Proof of Evidence Addendum

Land off Pump Lane, Rainham

APP/A2280/W/20/3259868 Prepared by Karl Jarvis

Prepared For: Medway Council

Figure 6 Comparison of Reference Case and Scenario 6A for subnetwork 2 in the morning peak (8.45am)

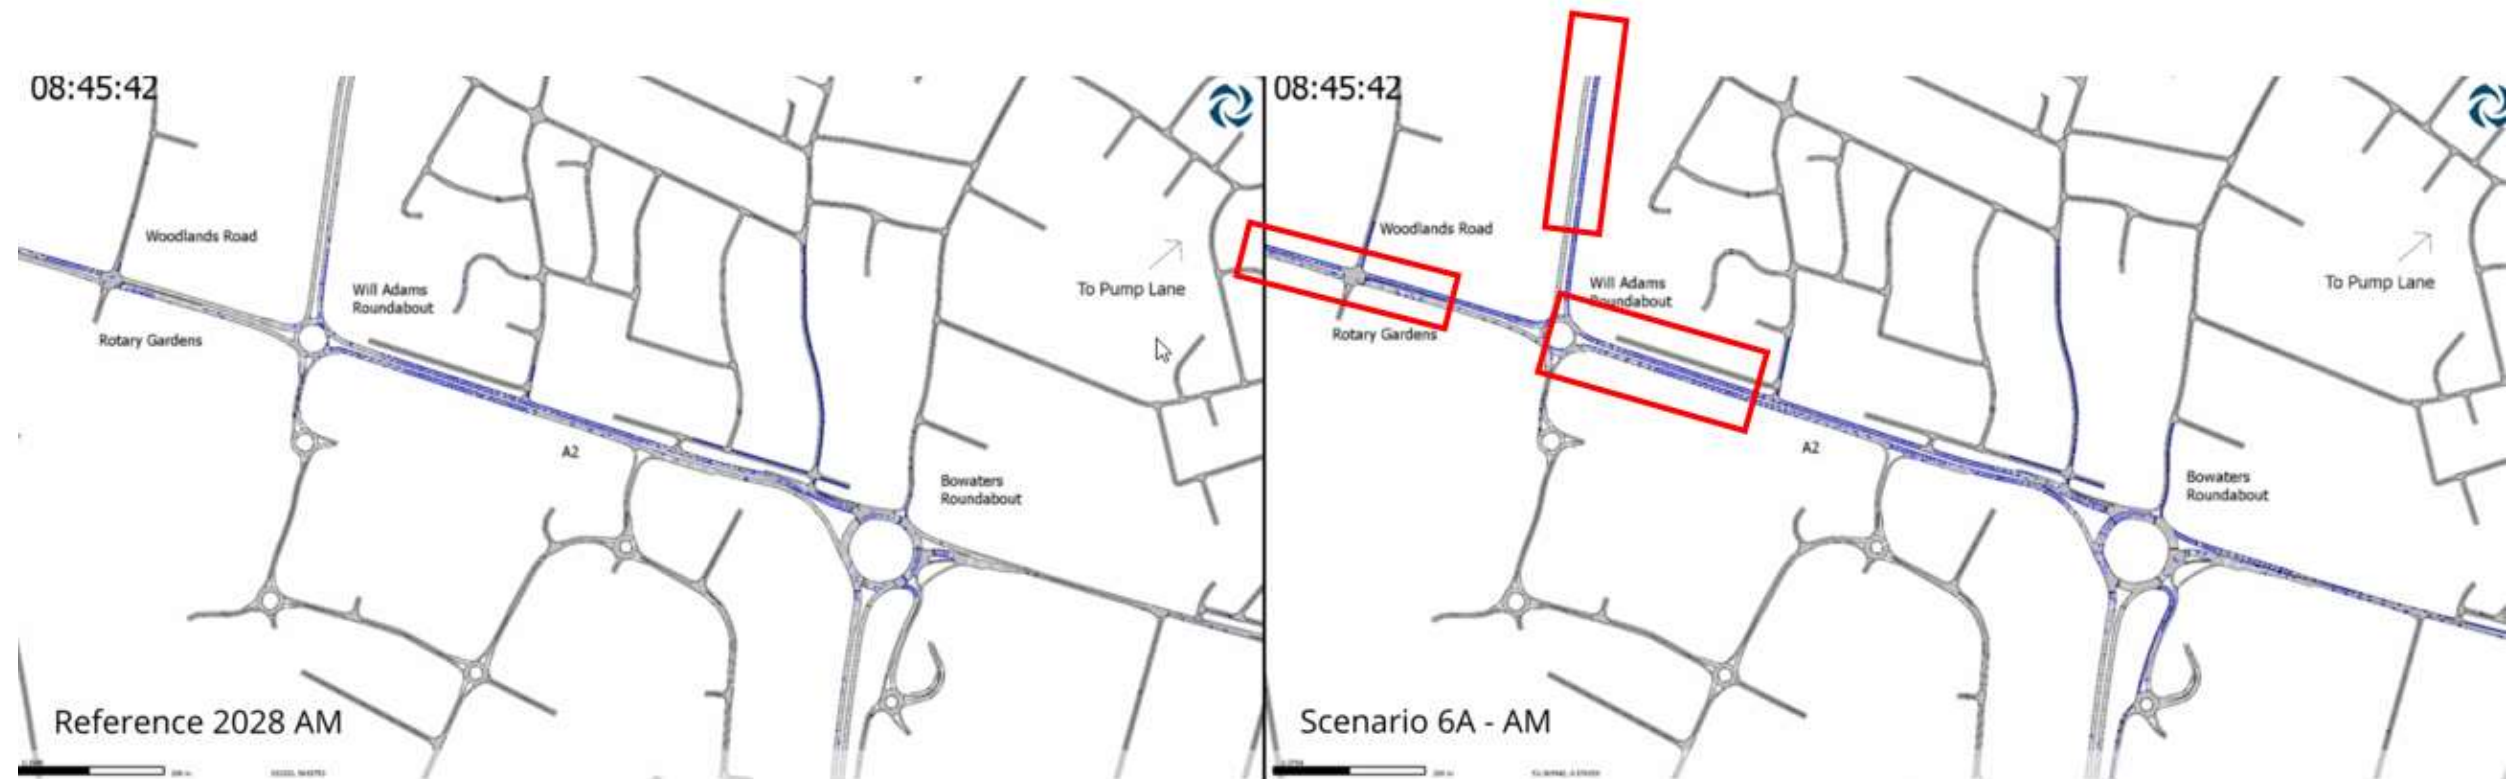
- 3.11 Figure 7 compares the Reference Case (without development) scenario with scenario 6a at 8.45am in the morning peak. Figure 7 shows resultant significant queuing along the A2 in both directions, eastbound A2 traffic blocks back over Will Adams roundabout. It can clearly be seen that, notwithstanding the additional mitigation, the traffic operations are far worse in scenario 6a compared to the reference case due to the additional development traffic despite the additional mitigation.

Figure 7 Comparison of Reference Case and Scenario 6A for subnetwork 2 in the evening peak (17.45)

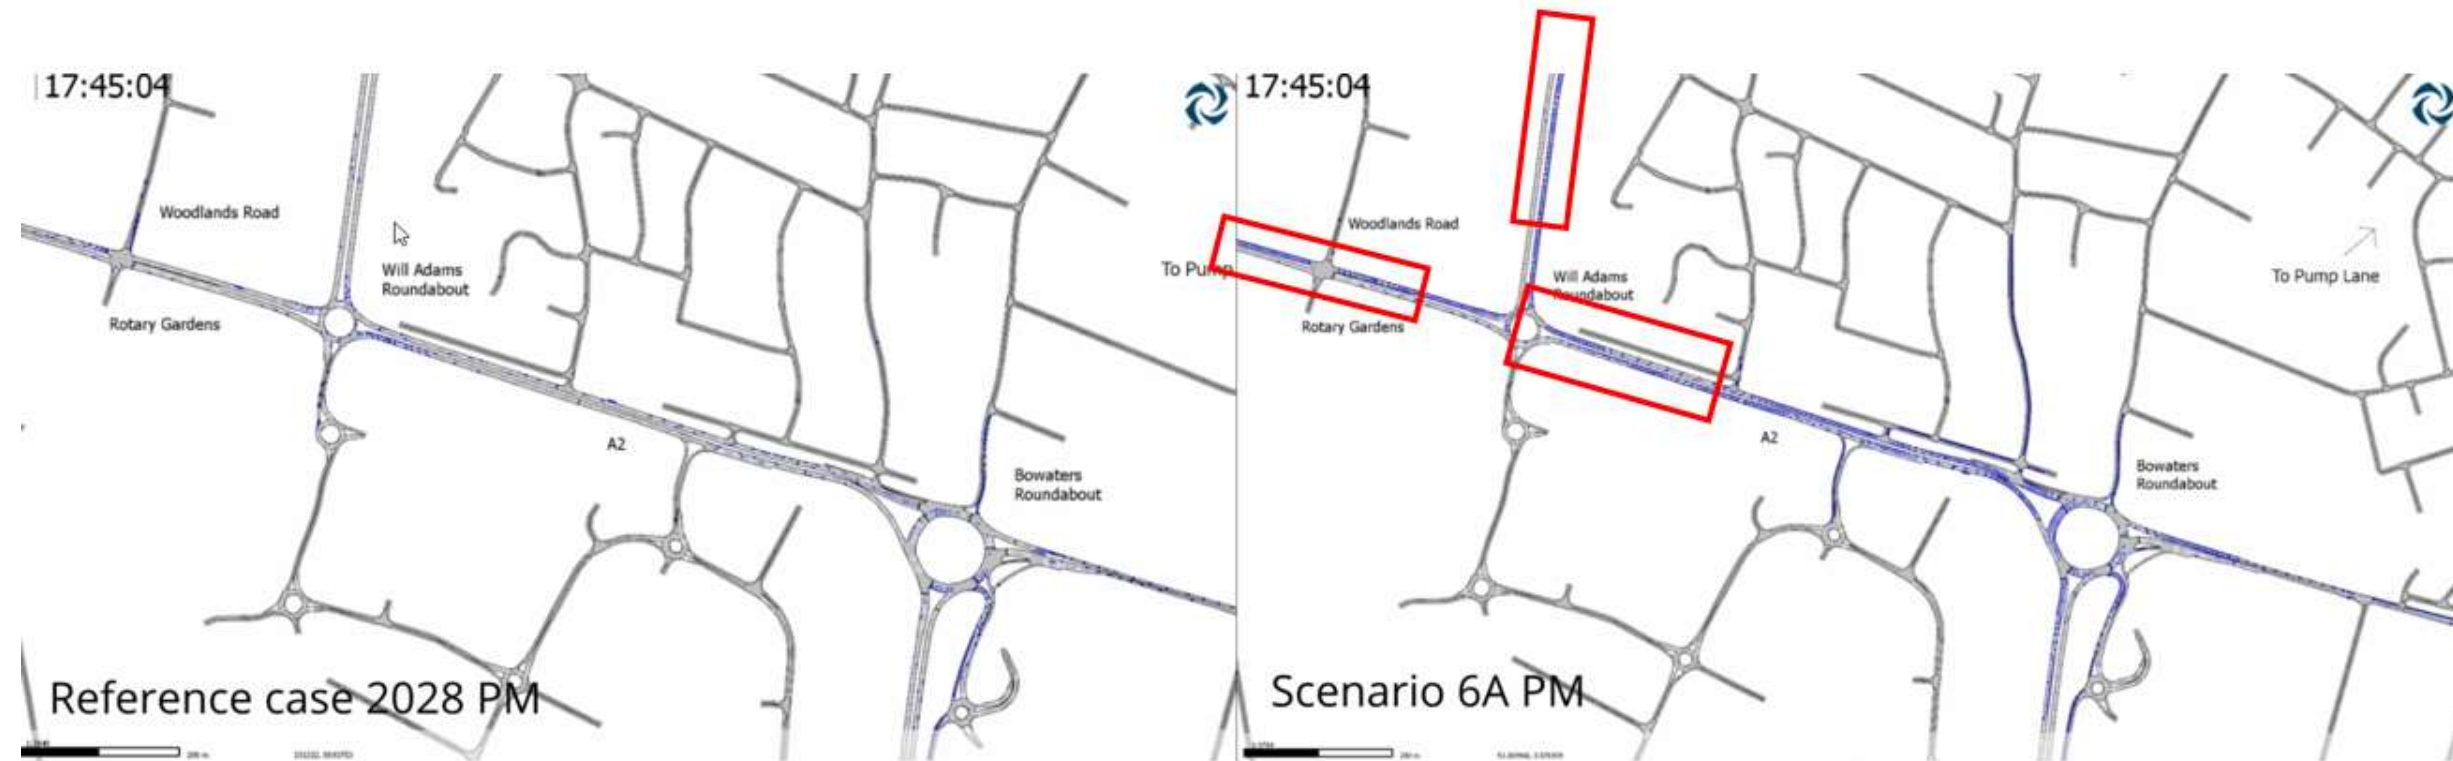
- 3.12 Figure 8 shows the equivalent comparison for 17:45 in the evening peak. It can be seen that there is significant queue in both directions on the A2 between Bowaters and Will Adams roundabout. The A2 eastbound queuing blocks back through Will Adams roundabout and the next junction which is the A2/Woodlands Road and Rotary Gardens as well as up Ito Way (A289). This has worsened compared to scenario 6 (with the additional mitigation) due to the reduced green time for the eastbound stream at Bowaters roundabout in the evening peak. It can be clearly seen in Figure 8 that the queuing and traffic operational degradation is far worse than the reference case scenario without the proposed development and additional mitigations.

Figure 8 Comparison of Reference Case and Scenario 6A for subnetwork 3 in the morning peak (8.45am)

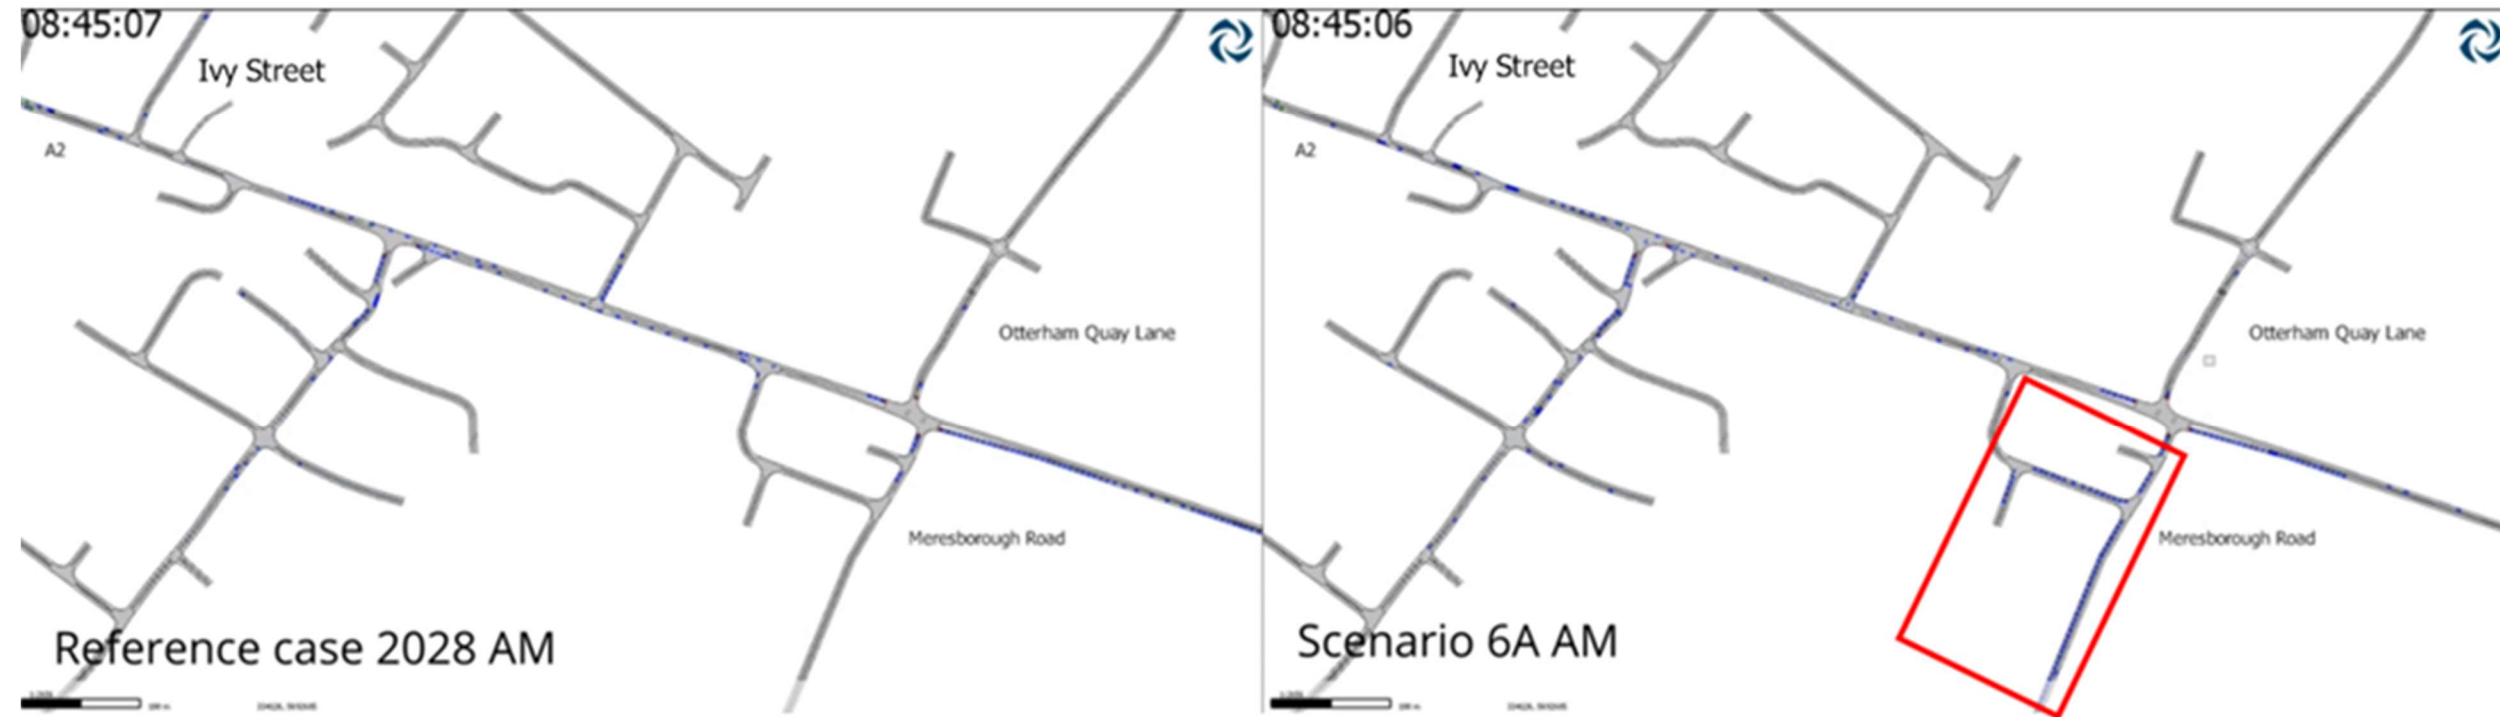
3.15 Figure 9 and 10 show screenshots taken at 8.45am and 17:45 that compare the Reference Case (without development) scenario with scenario 6a. Long queues can be seen on Meresborough Road in both time period which has reduced green time with the revised signal timings provided by the appellant, resulting in queuing back past Moor Park Close in scenario 6a, with a total queue length of some 200 metres.

Figure 10 Comparison of Reference Case and Scenario 6A for subnetwork 7 in the morning peak (8.45am)

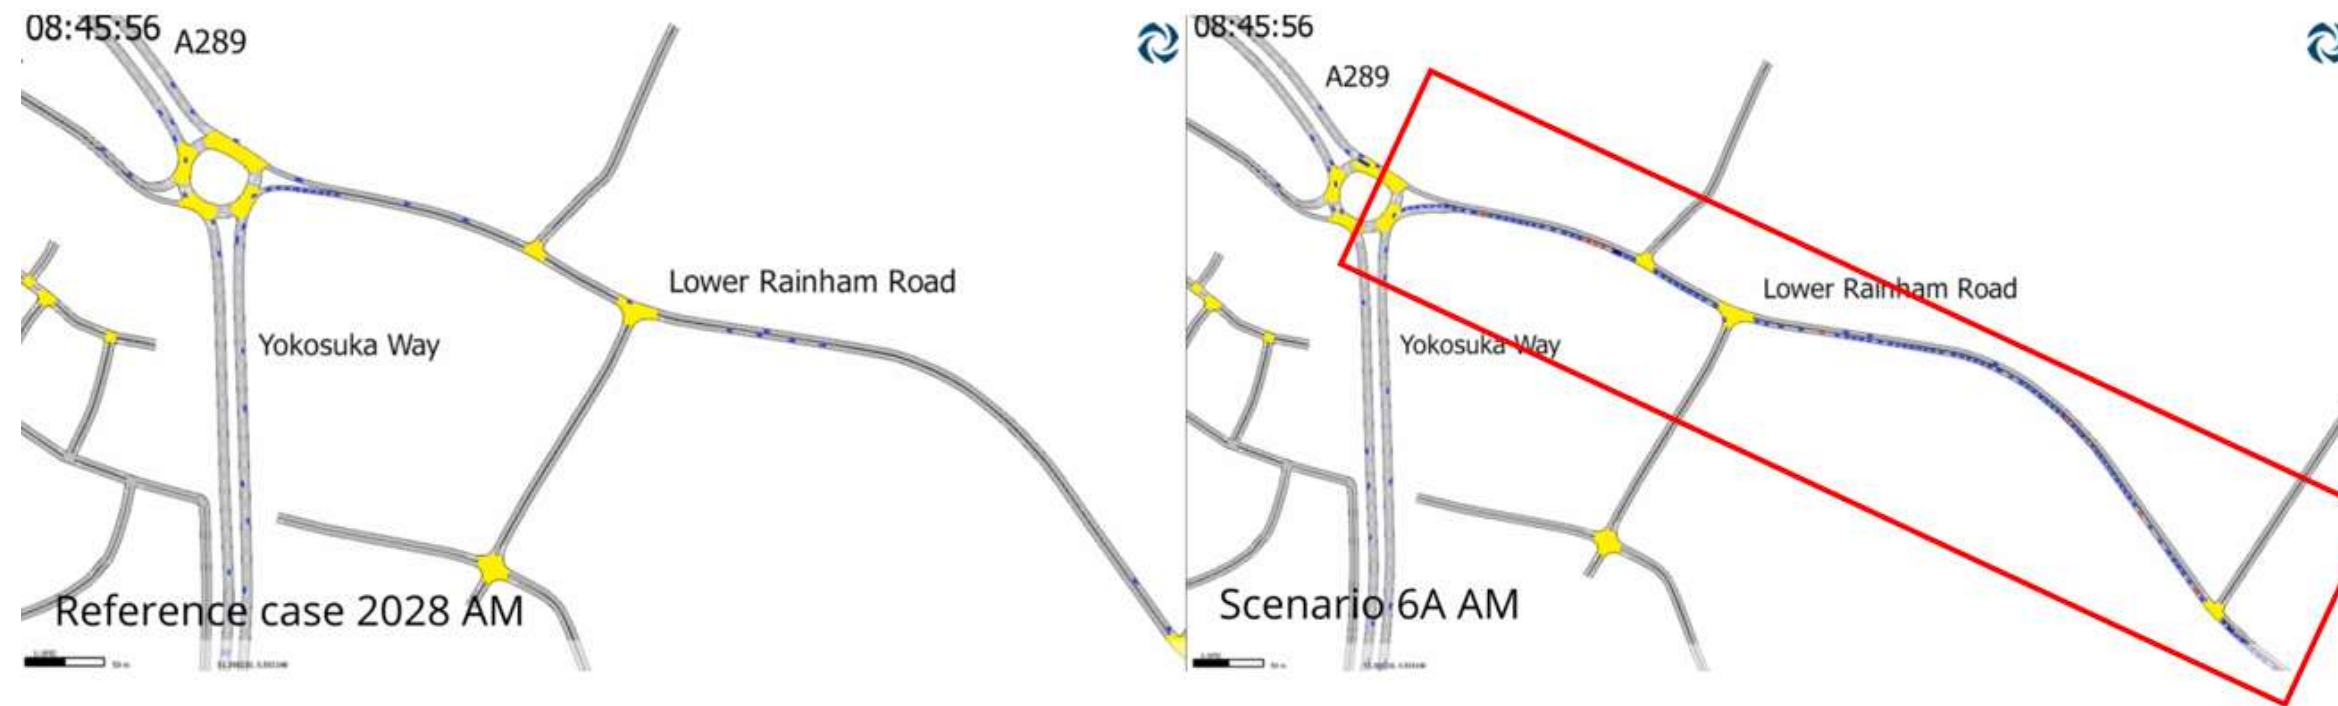
- 3.19 The main impact, as before, is the significant queuing on Lower Rainham Road westbound in the morning peak on the approach to the roundabout with Yokosuka Way. Here the right turning traffic heading northbound struggles to exit given the flows on the A289, with a significant queue forming along Lower Rainham Road past Sharps Green. This can be seen in Figure 11 which shows a screenshot from the micro-simulation video. This results in additional journey times along Lower Rainham Road of over 9 minutes due to the development traffic compared to the Reference Case (was 7 minutes and 9 seconds in the 2028 reference case, and 16 minutes and 16 seconds in Scenario 6A).

- 3.20 It should be noted that given this subnetwork includes the development zone it is possible to highlight vehicles going to and from the development a different colour (i.e. red) compared to general traffic (i.e. blue) in the micro-simulation video. It is also worth noting that the additional A2 mitigation does remove some traffic from Lower Rainham Road and onto the A2, resulting in a marginal improvement in journey times on Lower Rainham Road westbound compared to the previous scenario 6 without the additional mitigation. It is still however significantly worse when compared to the Reference Case.

Figure 11 Updated Proposed Mitigation for Lower Rainham Road and Yokosuka Way Roundabout

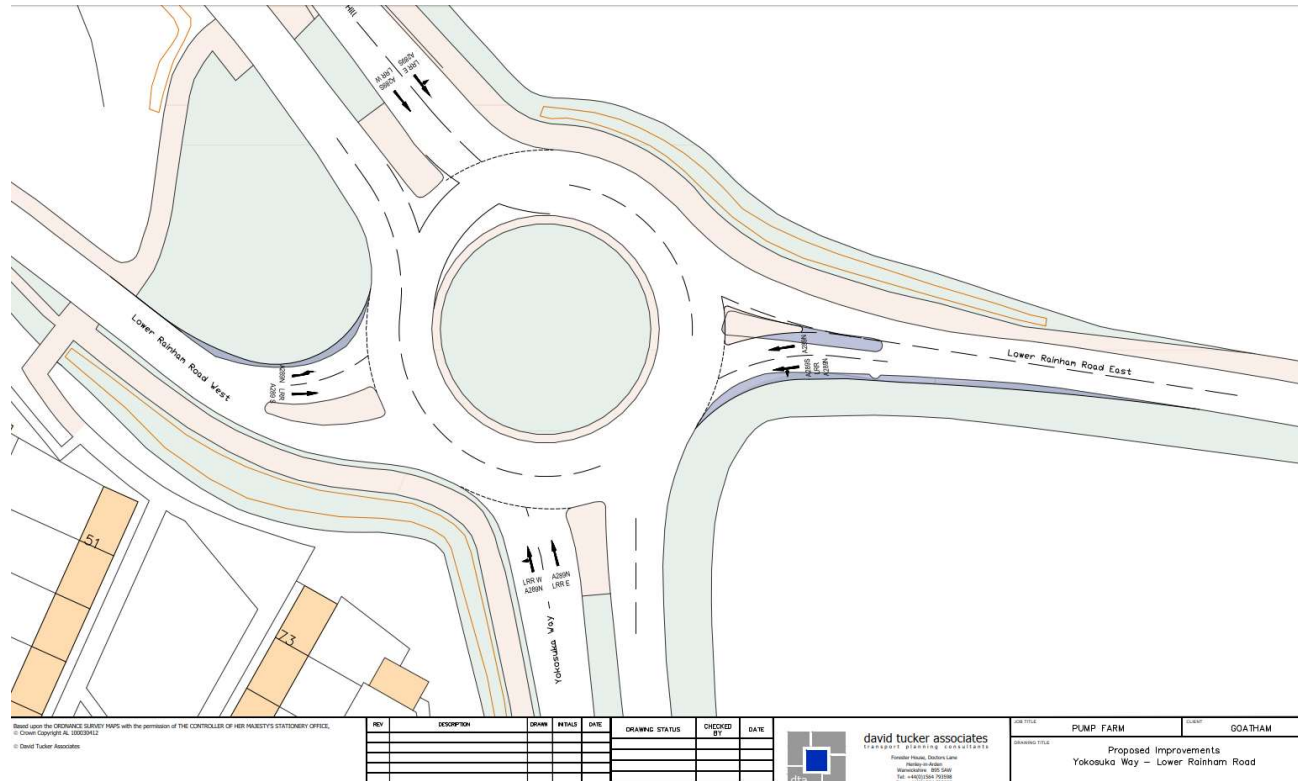
- 2.18 Figure 12 provides the drawings for the revised mitigation. This shows for the Lower Rainham Road eastern approach arm the arrows show one shared left and straight-ahead movement and one straight ahead however the text would suggest that both lanes could be used for the right turn movement from Lower Rainham Road to A289 North.

- 4.2 Figure 12 shows the plan that was attached to Mr Tuckers email on the 28<sup>th</sup> of February 2021 regarding revised mitigation on Lower Rainham Road and Yokosuka Way. It can be seen that the small text on the Lower Rainham Road westbound approach to the Yokosuka Way roundabout does refers to two right turn lanes to the A289 northbound. There are however clear inconsistencies with the arrow markings, which show two straight ahead movements instead.

- 4.3 This revised mitigation only came to Sweco’s attention following tracked change comments by Mr Tucker in his statement of common ground edits provided on 17:03 on the 7<sup>th</sup> of April 2021. In his tracked changes Mr Tucker added a mitigation referring to “additional flaring and amended lane markings Yokosuka Way / Lower Rainham Road”. He then also states that “the physical mitigation works at Yokosuka Way – Lower Rainham Road is not included in the modelling”. This is for the good reasons outlined above, this was the first time we were made aware of the Appellant’s further revised and additional mitigation outside the A2 corridor.
